ADDENDUM 5

BID TITLE: File No. 55-24 Green Road Pump Station

GREEN ROAD PUMP STATION– FILE NO. 55-24

DRAWN BY: VKN	SCALE: 1"=20'	CWD NO:	SHEET NO:
DESIGNED BY: AD	DATE: 12/2021		C-01
CHECKED BY: AJA

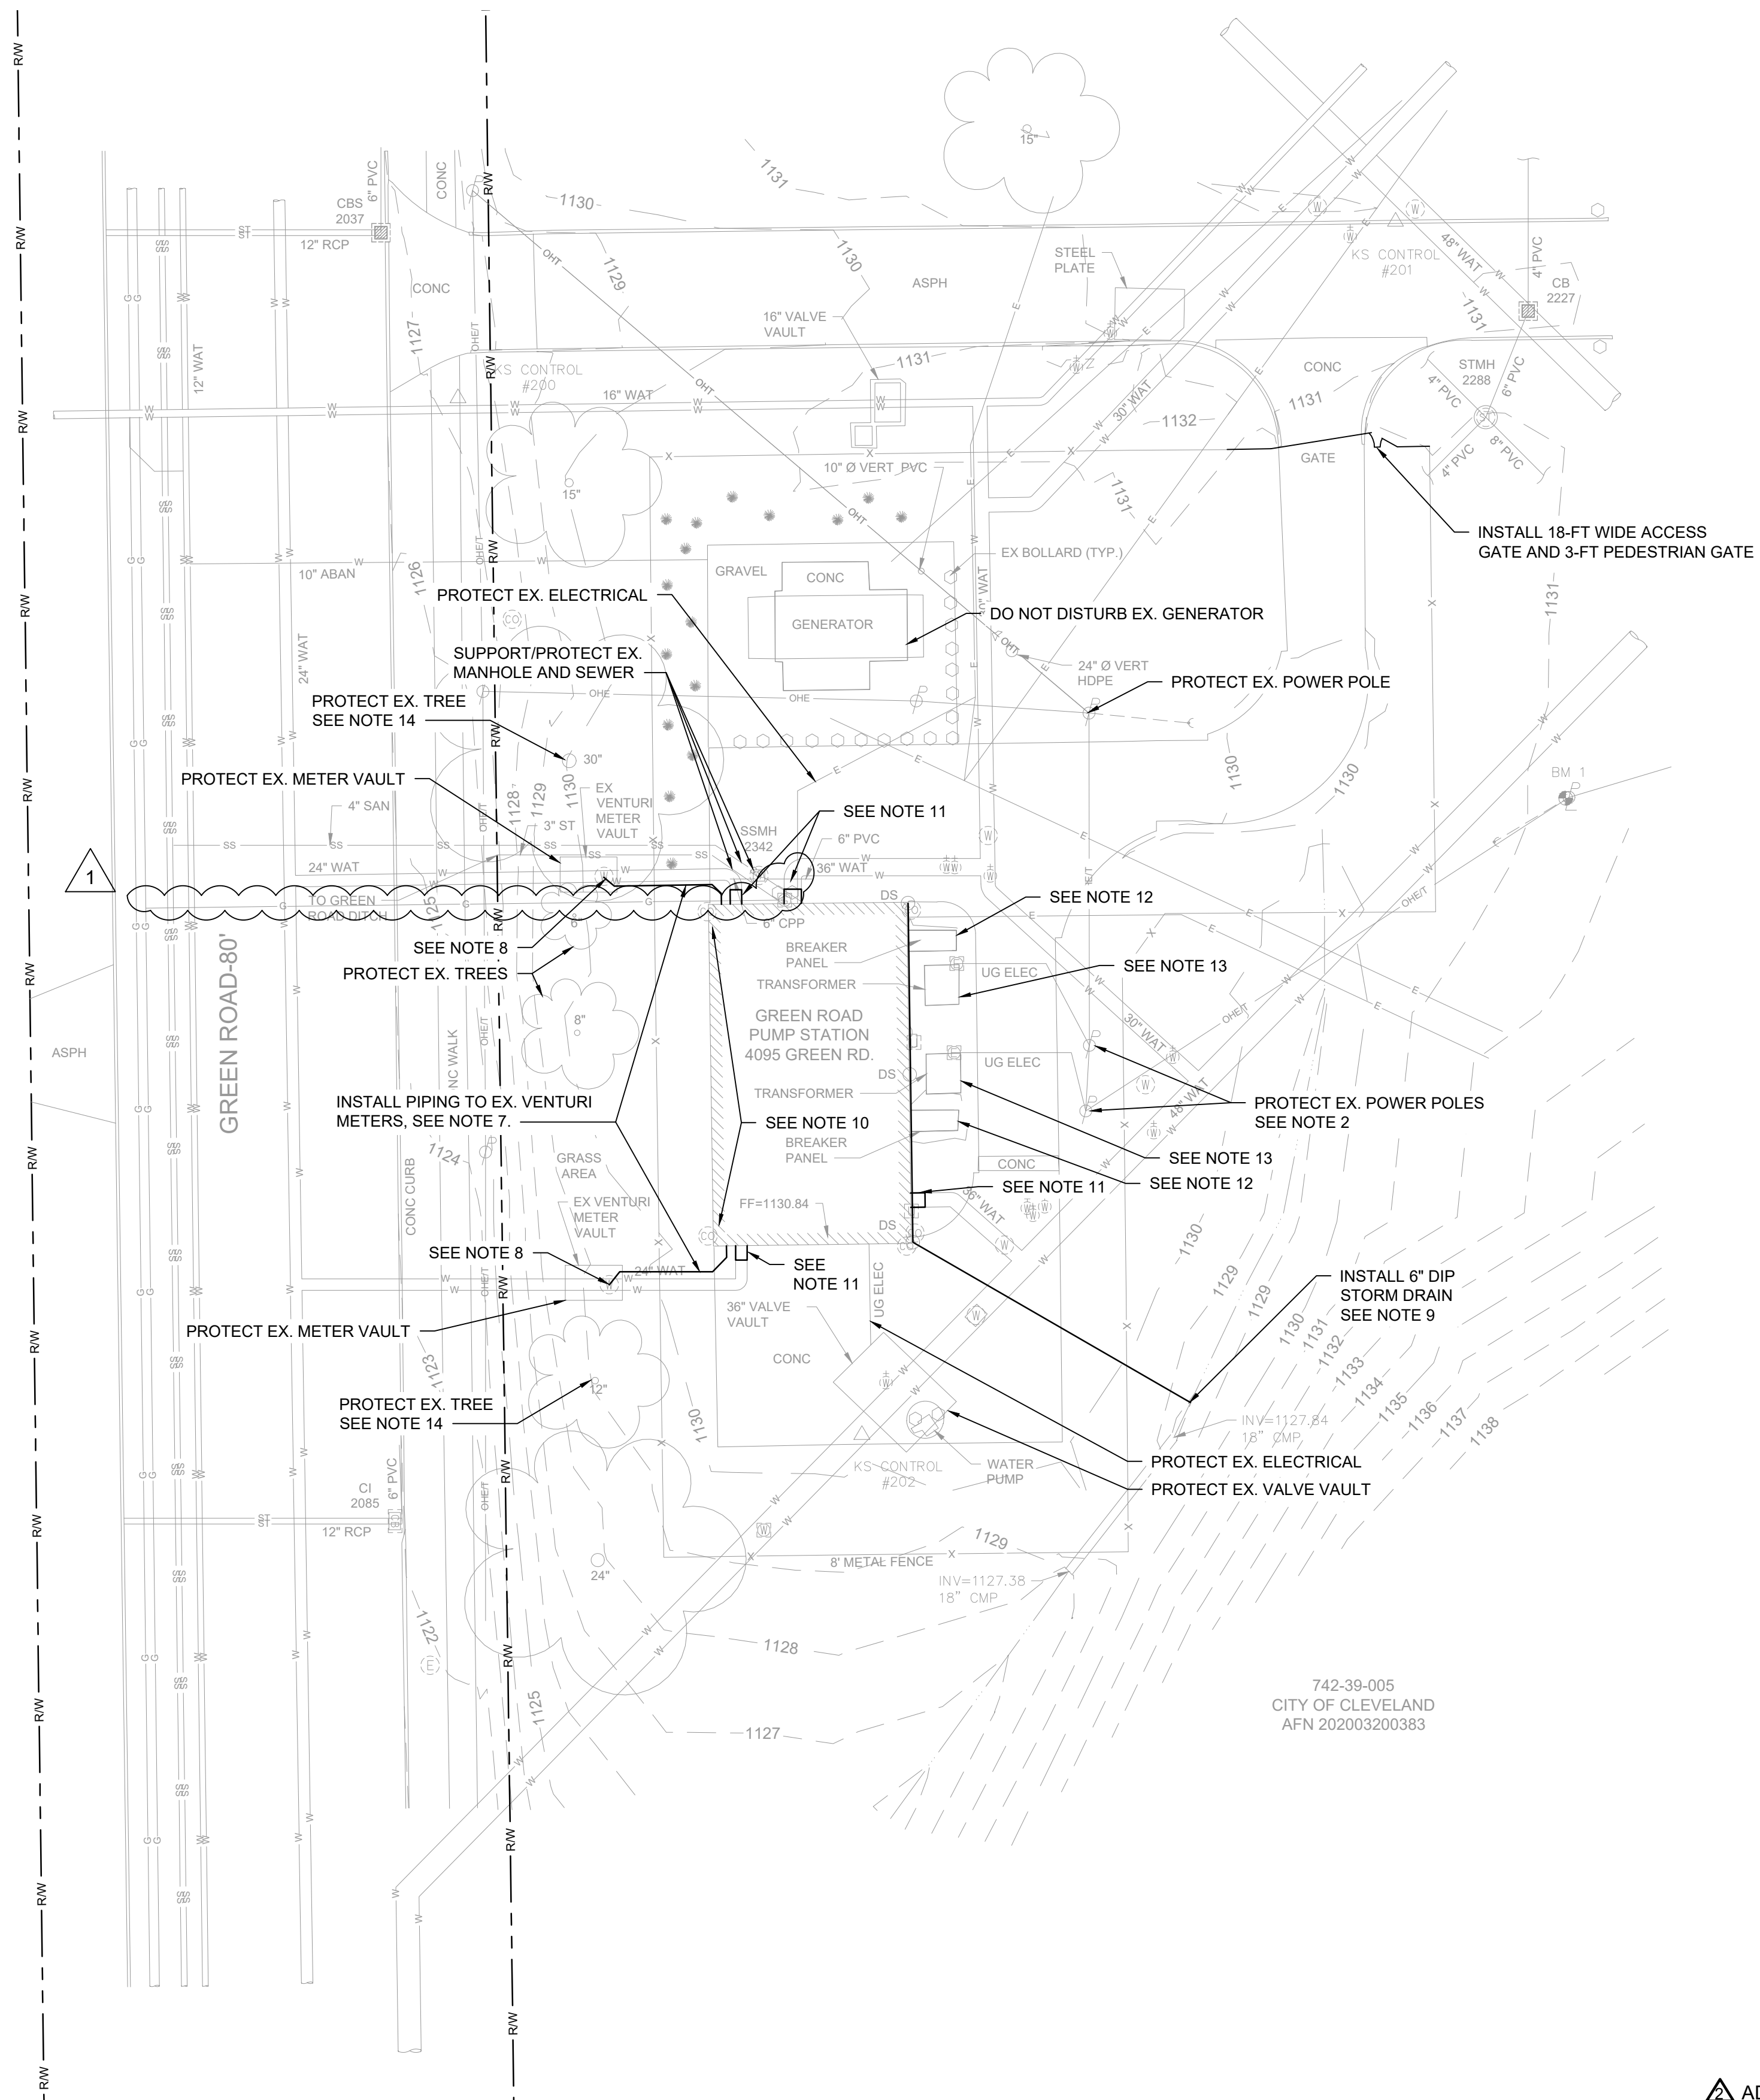
1. C-01 - Showing approximate routing of gas service.
2. C-03 - The gate detail was revised to reflect an ornamental security gate instead of a chain link gate, to match the rest of the existing gate.
3. I-05 thru I-10 and I-20 - Revised to include an intermediate position limit switch on the discharge check valves, and to include check valve closed as a start permissive for the pumps.
4. E-12 - Revised to add a CAT6 cable from each pump local control panel to the master control panel.

25. On the North side of the pump station the contractor is to replace 2 sections of piping on the 36" and 24" intake/discharge lines to a point 2.5' outside of the building. When excavating for the 36" stub there is an existing gas meter/feed shown on the plans, however, the gas line service from the main is not shown in the plans. Please indicate approximate routing of gas line from the main to the meter and the specific size/material of the existing service.

Answer: See revised C-01 in this addendum showing approximate routing of gas service. Based on Dominion East Ohio provided information, gas service is assumed to be 1" steel.

ORNAMENTAL SECURITY GATE
NOT TO SCALE

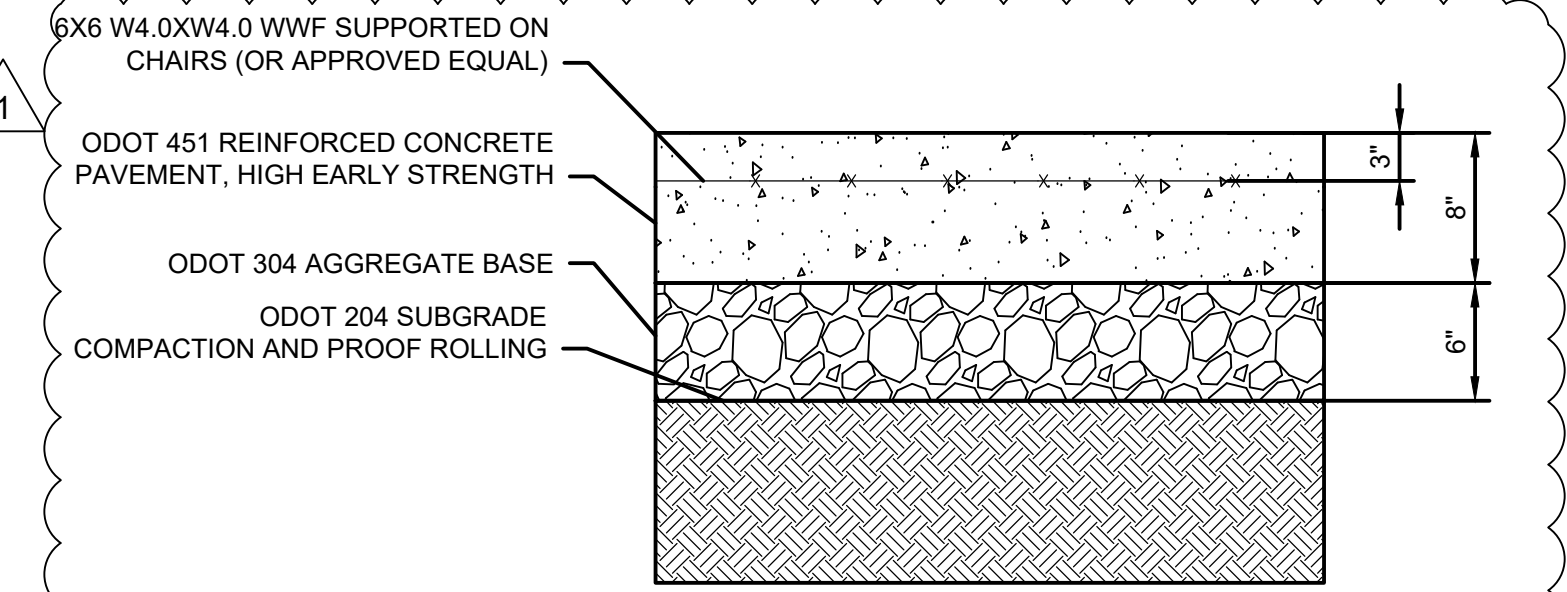
1. Section 32 31 13 – Chain Link Fence and Gates is deleted. Refer to the detail on sheet C-03 for ornamental security gate requirements.

CITY OF CLEVELAND	
CLEVELAND DIVISION OF WATER DEPARTMENT OF PUBLIC UTILITIES CLEVELAND, OHIO	
SUBJECT CYCLE H - GREEN PUMP STATION	
PUMP LOCAL CONTROL PANEL DETAILS 1 OF 2	
DRAWN BY: SJT	SCALE: NTS
DESIGNED BY: SJT	CWD NO:
CHECKED BY: VM	DATE: 12/2021
SHEET NO: I-09

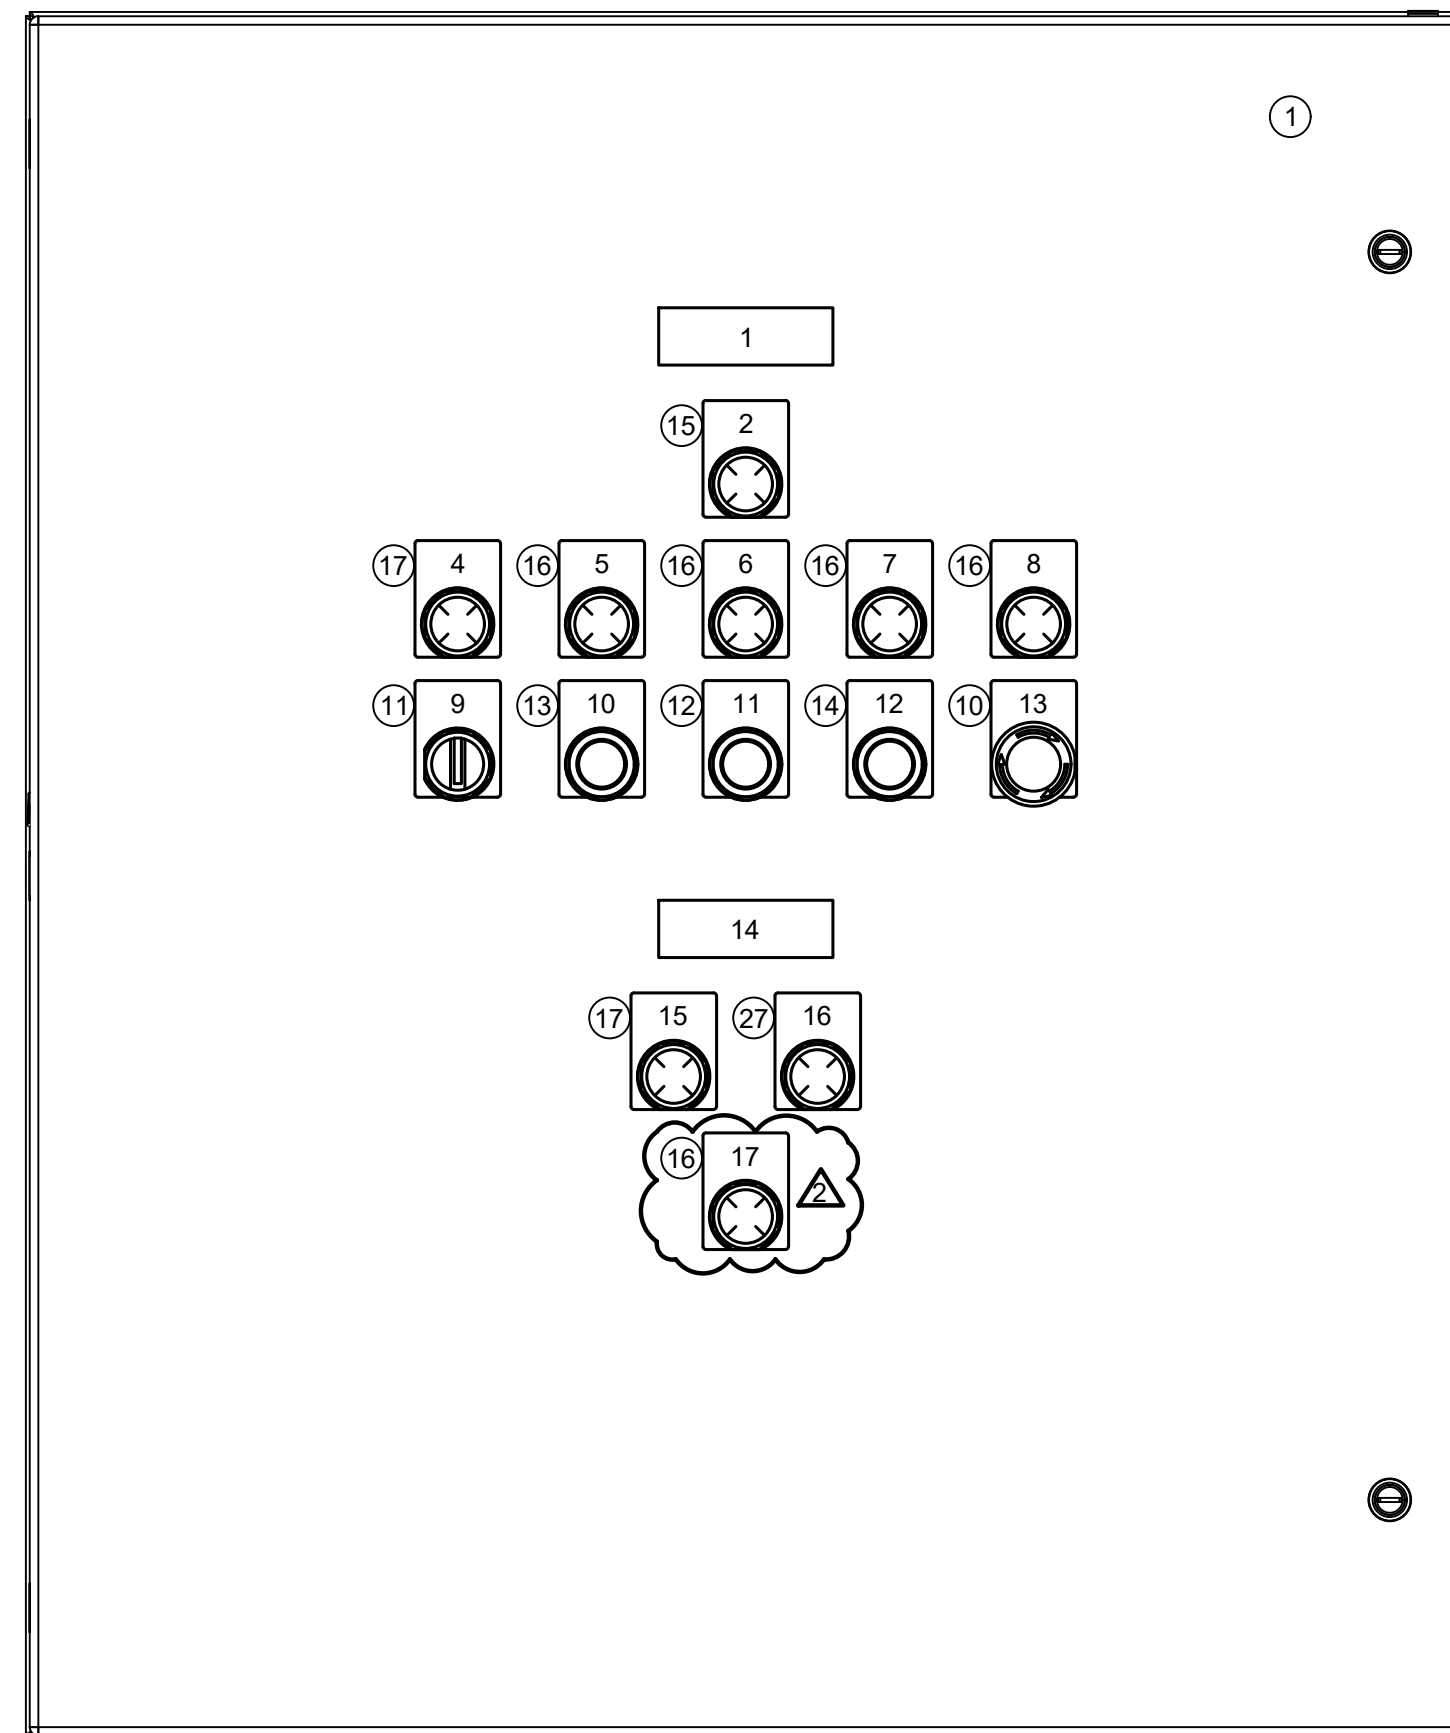
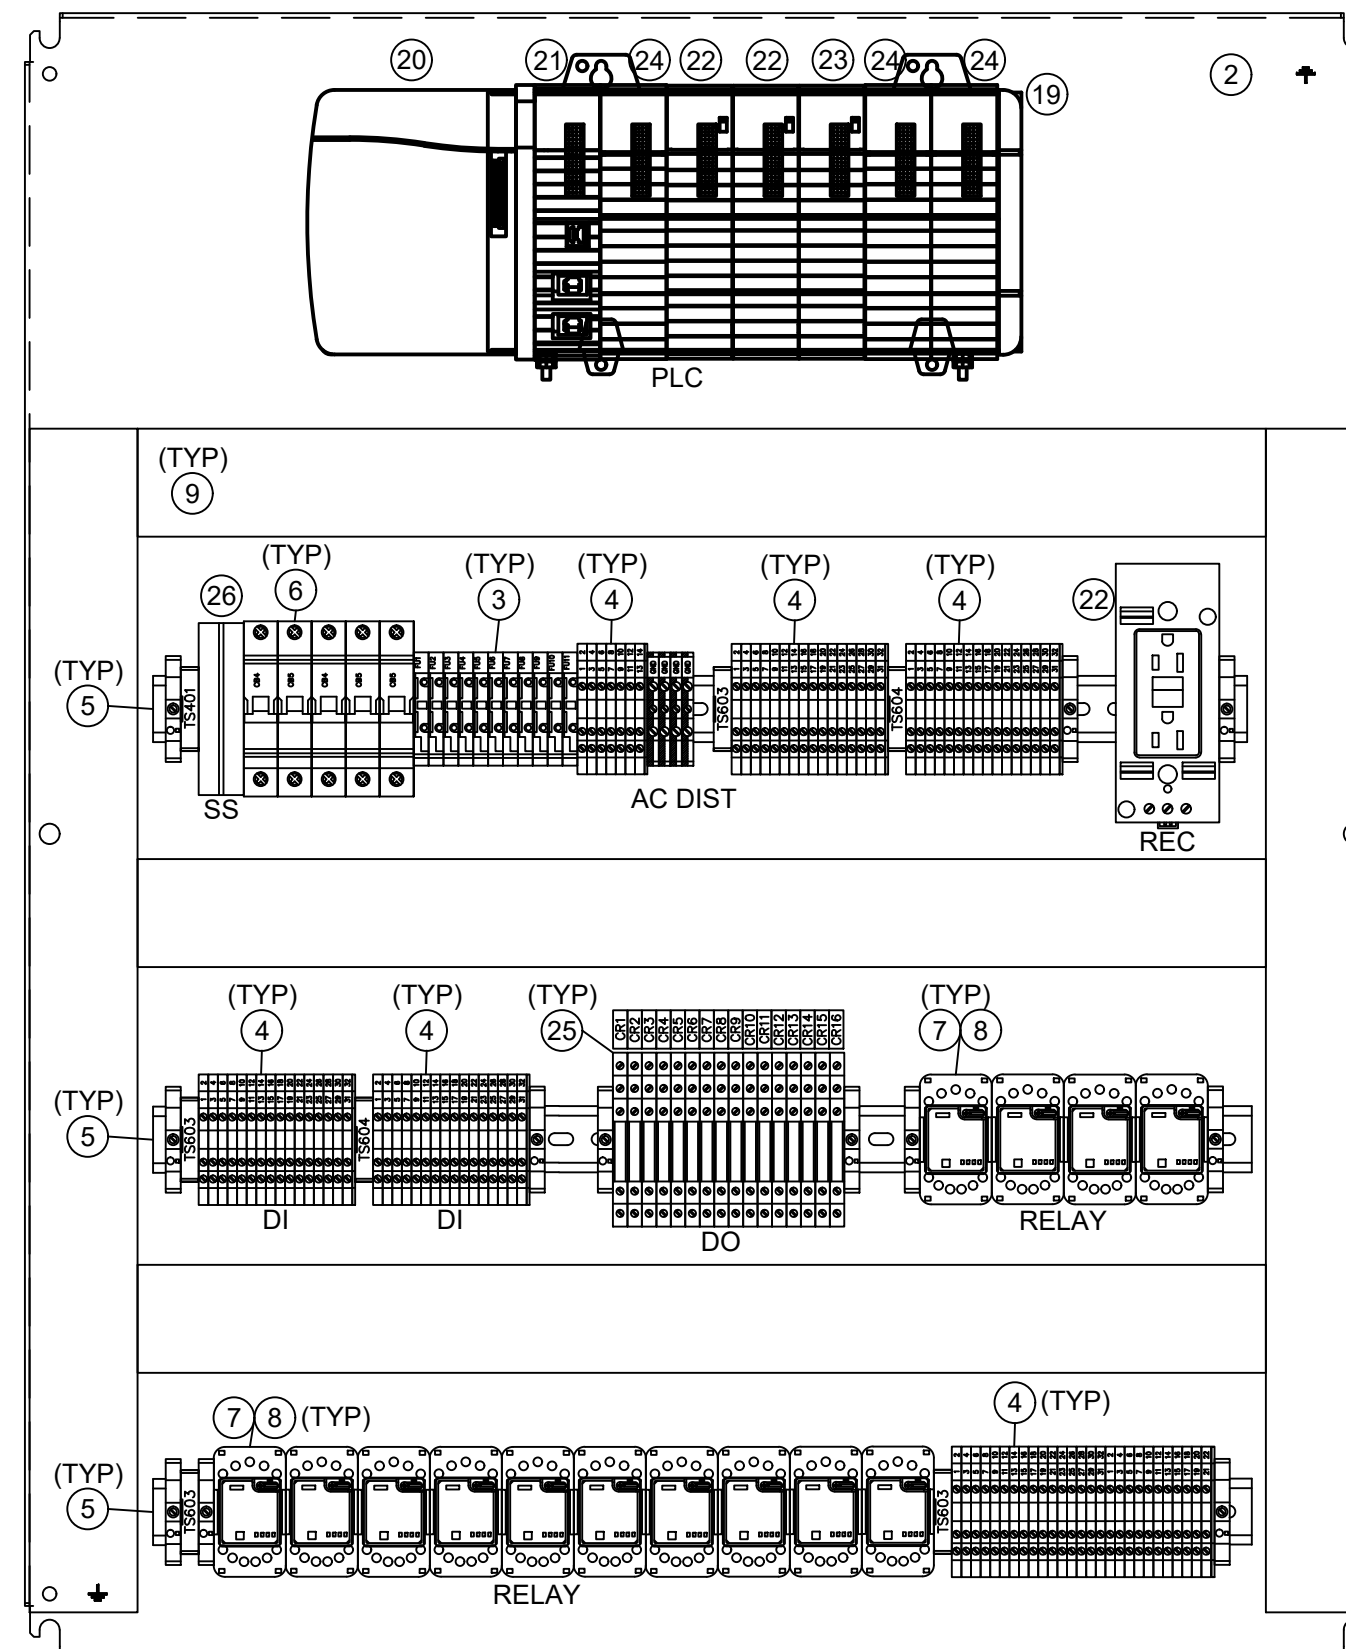
2. The ball check valves with hydraulic actuators are specified to operate with slow and fast speeds. At other CWD pump stations this is done with open, intermediate (20% open) and closed limit switches mounted on the valve that communicate with the associated pump LCP. The pump LCP then commands solenoid valves on the hydraulic actuator control panel for slow/fast open and closed. These switches and positions are not indicated in the valve specifications or on the ladder diagrams for the pump LCPs. This would provide local control of pumps if the RTU is out of service. Please provide additional information on the logic for opening and closing the ball check valves in coordination with pump start/stop.

Answer: The ball check valves shall include an intermediate limit switch in addition to the open and closed limit switches. Ladder diagrams have been modified to incorporate the intermediate limit switches and slow and open commands.
